Access Compliance Report

Public Rights-of-Way

(Curb Ramps)

Intersection ID: 29818	Main Street: WEDGEWOOD COMMONS DR	Cross Street: MINA CT	Location: SW
ADA ID: FF9D7B242FC3	Ramp Type: PerpDiag	Initial Pass/Fail: Fail	Overall Compliance: No
Codes/Mitigation Info/Possible Solution		Field Measurements/Component Compliance

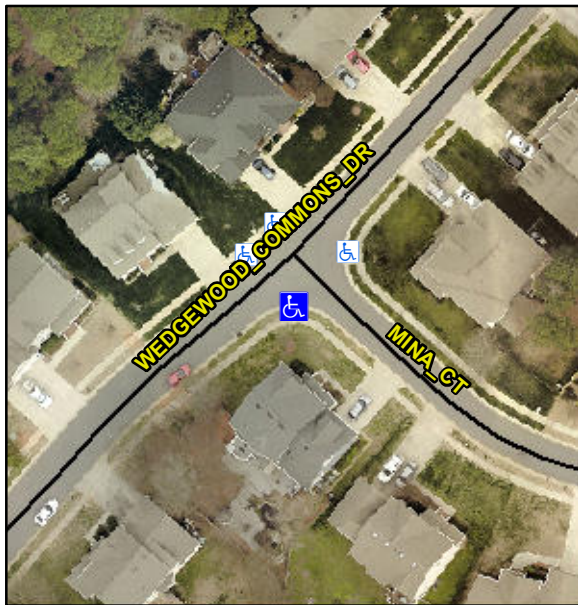
Possible Solutions:

Remove & Replace Curb Ramp With Two New Directional Ramps or Equivalent.

PROW/ADA:

R304.2.2, R304.5.3
